# **Decision Report**

## **Application for Works Approval**

Works Approval Number W6736/2022/1

Premises Jenour Liquid Waste Facility

Figure 1 New WRR

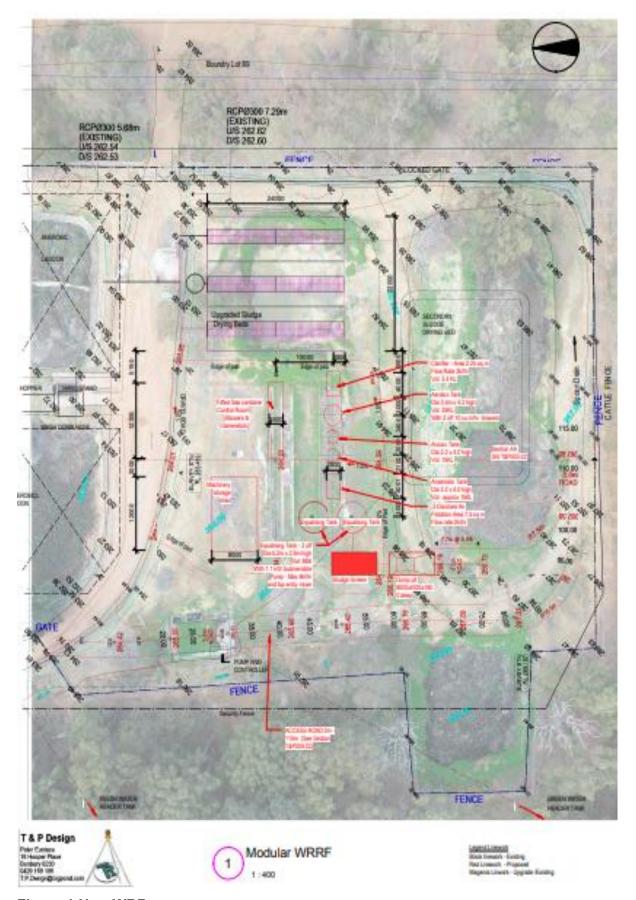
This information can be submitted to DoH. Based on the RFI letter to the Applicant 5 January 2023, outlining concerns about the suitability of the Polishing Wetland, the Applicant has re-designed the WRRF and removed the Polishing Wetland from the process. It has been replaced with an additional anaerobic tank and sand filter.
<u> </u>

An additional anaerobic tank with blowers will be added to enhance biological phosphors removal. In this design the total nitrogen of the final effluent will be <14mg/L (Table 4). An additional media/sand filter can be added for enhanced suspended solids removal and will be located in series with the first filter.
